**DOCUMENT 00 90 10**  
**ADDENDUM No. 1**

- A. The Construction Contract is known as Ogden City 2018 Traffic Signal Upgrades.
- B. Date of this Addendum: November 19<sup>th</sup>, 2018

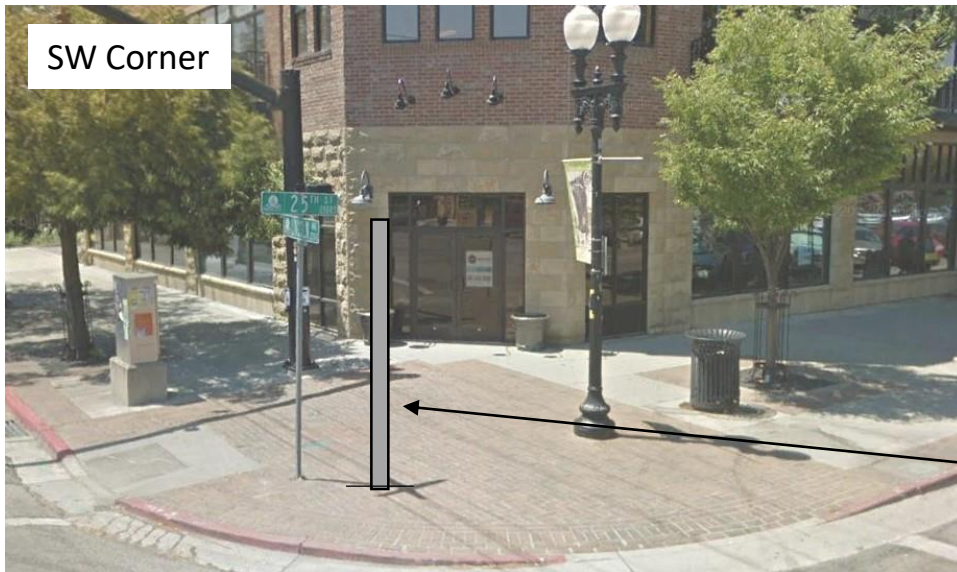
- A. Update to Exhibit 1, Sheet SG-9b: Note changed to clarify that Ogden City will provide a separate contractor for reinstallation of the pavers on all corners, as needed for conduit installation, but not for removal of the pavers. Included "POWDER COATED" to note regarding 11' pedestrian signal pole, indicating that the powder coated pole is to be installed at the Southwest corner of Lincoln and 25<sup>th</sup>.

- Notes:
- Ogdan City will provide a separate contractor for reinstallation of the pavers on all corners, as needed for conduit installation.
  - If relocated buttons on decorative light posts cannot be installed without the panels conflicting, the Contractor will be required to use standoff brackets on one or both panels. Inverted panel installation will not be accepted.

Install 11' **POWDER COATED** ped pole here, relocate ped buttons. Center between the ramps. Standoff brackets are required if necessary. Relocate street signs to this pole and remove post.
